Commission Agenda Report

Planning Commission Meeting
04-17-23
Item 5.B.

Subject: Malibu Inn Motel - Coastal Development Permit No. 09-067, Mitigated Negative Declaration No. 20-003 and Initial Study No. 20-003, Conditional Use Permit No. 18-002, Variance Nos. 18-030, 18-031, and 20-035, and Site Plan Review No. 18-025 – An application for development of a motel project

Location: 22959 Pacific Coast Highway, within the appealable coastal zone
APN: 4452-019-005
Owner: Surfrider Plaza, LLC

Figure 3 – Representative Cross Section

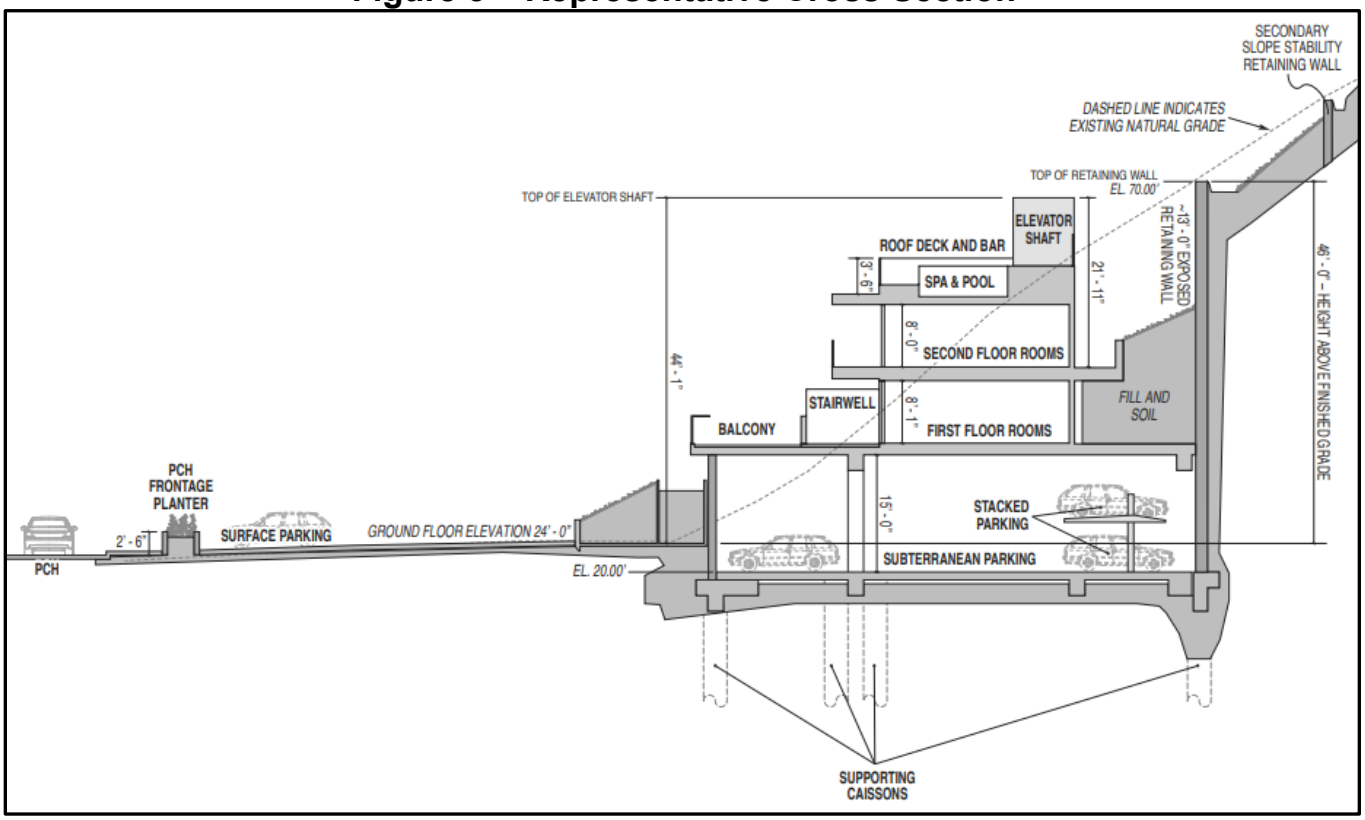
My first point of opposition is that there is no relief in our LIP for a retaining wall that is fifty feet tall (the dimensioning of their figure 3 is incorrect), with thirteen feet exposed, and a secondary retaining wall behind it.

Although described as subterranean parking, to say the parking structure is subterranean is misleading since only about 4 ft is actually underground. This parking structure is not subterranean since the majority of the parking is above ground level. (See figure 3 ND.)

8.1 My first point of opposition is that there is no relief in our LIP for a retaining wall that is fifty feet tall (the dimensioning of their figure 3 is incorrect), with thirteen feet exposed, and a secondary retaining wall behind it.

Thank you for the comment regarding the proposed Malibu Inn Motel Project Draft IS-MND. The commenter opposes the Project partially because the City's Local Coastal Program Local Implementation Plan has no relief for a retaining wall that is fifty feet tall (states the Figure 3 dimensions are incorrect) with thirteen feet exposed. The commenter asserts the findings for variance for the Project's grading and the retaining wall cannot be met effectively.

The comment notes that the proposed retaining wall could impact the visual character of the area, although the wall would not be visible to passersby on PCH. The comment incorrectly states Figure 3 is inaccurate in regards to Figure 3's retaining wall height. As described in Section 1.3, *Project Description*, of the IS-MND, the back support wall would be a height of 46 feet above finished grade and approximately 52.5 feet above the finished floor elevation of the subterranean parking level. Therefore, Figure 3 is accurate in its depiction of the retaining wall. Further, a variance would be required for the proposed installation of a retaining wall taller than 6 feet and on a slope steeper than 2.5 (horizontal) to 1 (vertical) slopes.

Figure 3 – Representative Cross Section

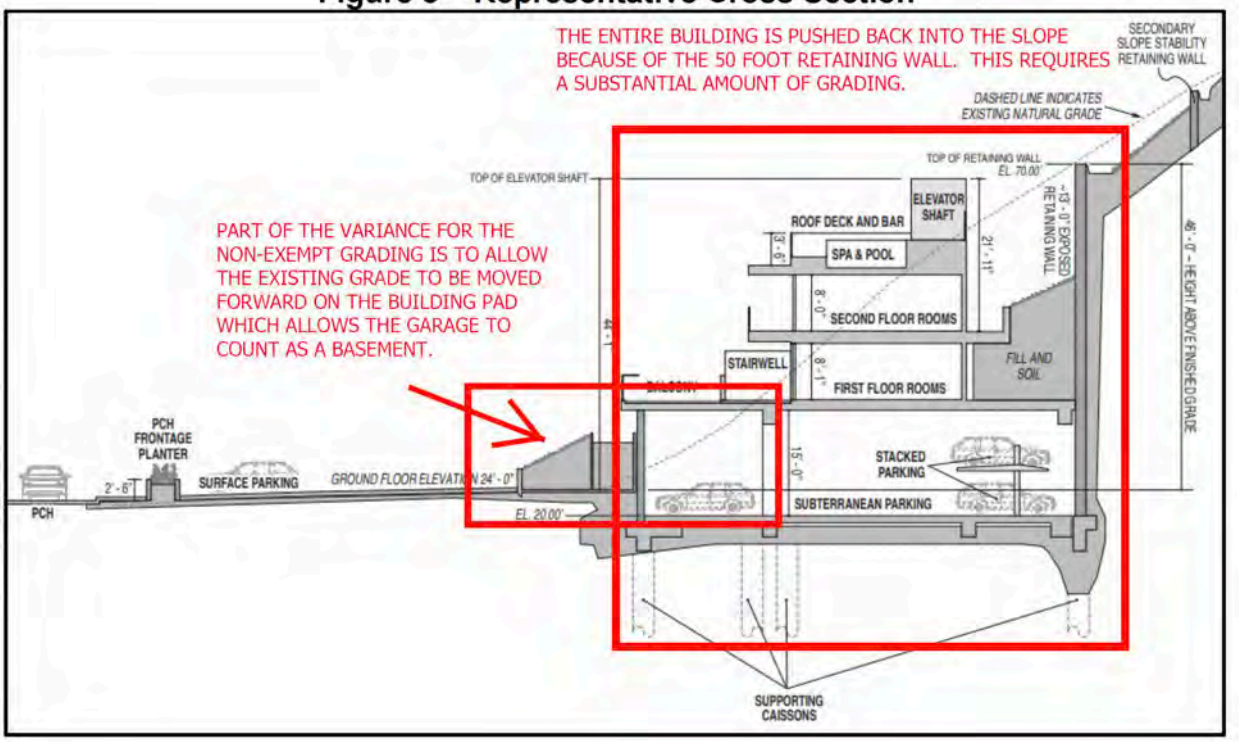
honest staff report would have required the applicant to analyze the grading differential between a design that did not require the fifty foot retaining wall, and the yardage presented. (see image below).
